## Staff Report to the Zoning Administrator

Application Number: **06-0077**

**Project Description:** Proposal to develop a commercial dairy with 60 cows and to construct a milking parlor of 2,777 square feet, free stall barn of approximately 7,000 square feet, hay barn of 1,024 square feet, composting barn of 7,120 square feet, interior remodel of the existing processing plant under Building Permit application 58573G, install a septic system, construct ~~corral~~ fencing and access driveway and parking improvements, and approximately 420 cubic yards of grading.

SEPTIC AND DRAINAGE SITE PLAN  
SCALE 1" = 20'-0"

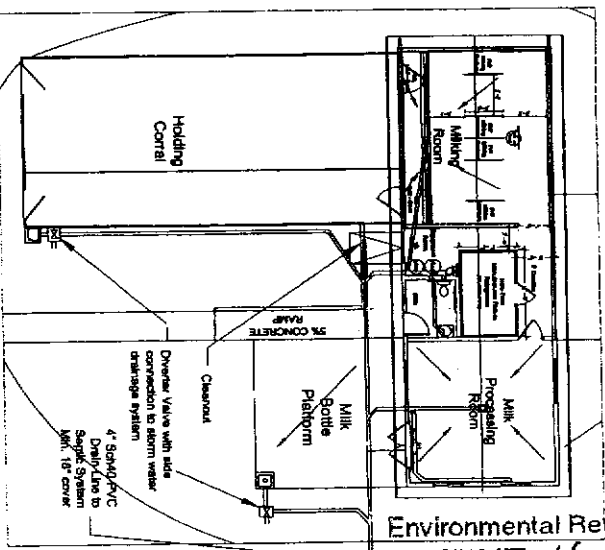
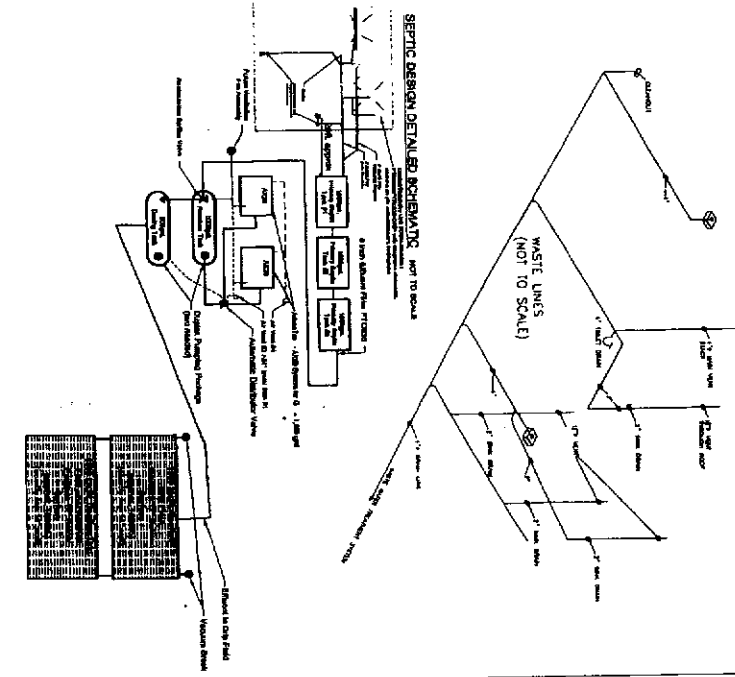
- a. Provide a drainage plan that shows all processing waste water, floor washing, and storm water run off being channeled into the Advantex water treatment system, along with written documentation from the Environmental Health Services Department that the system is adequately sized to accommodate that volume.

- b. Alternatively, the plan may show that clean roof runoff is routed to the existing pond if the Department of Public Works drainage staff reviews and accepts calculations that show the pond has adequate capacity to receive run off associated with a minimum 10 year storm.

- c. Provide calculations for the review and approval by Department of Public Works drainage staff that demonstrate that post development runoff will not exceed pre development runoff for a minimum 10 year storm.
